FTI-STP1 v 1.0 A/T Application Bulletin/Advisory

MODIFICATION REQUIRED FOR A/T APPLICATIONS, ONLY WITH v 1.0 HARNESS

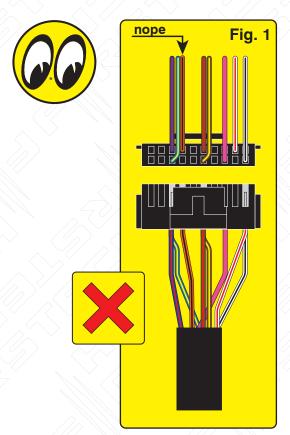
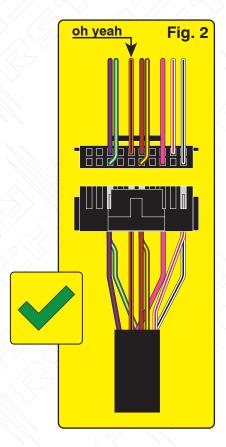
Overview: Production error in version 1.0 harnesses; The immobilizer wire (orange/black) is in pin position #4 instead of pin position #5. Although an effort to correct the issue was made, some quantity of harnesses did get shipped before the issue was spotted. We are advising to inspect the harness BLADE connector before attempting to install harness or program the module. This issue is not known to affect the version 2 harnesses, which require no modification.

ISSUE: Module fails to program correctly to vehicle, does not allow the vehicle to be remote started.

Correction: Step 1.) Locate the orange/black wire and confirm whether it is positioned as illustrated in Fig. 1 or Fig. 2. If the wire is as illustrated in Fig.1, proceed with Step 2 through 5 and complete the repair procedure outlined, if the wire is as illustrated in Fig. 2, correction is not necessary, proceed with harness installation and module programming.

- Step 2.) Using a pick, lightly depress the catch that secures the terminal in the housing then remove the wire and terminal from the housing.
- Step 3.) Using a fine tip razor or utility knfe, inseret the blade beneath the terminal catch and raise it slightly, so that it can be reused to secure the terminal when reinserted into the BLADE connector housing.
- Step 4.) Refer to Fig, 2 for correct position of the orange/black wire (next to brown/red) then reinsert the terminal, pressing lightly until the catch 'snaps' into place, securing the terminal in the connector housing.
- Step 5.) The repair is complete, proceed with installation and programming.
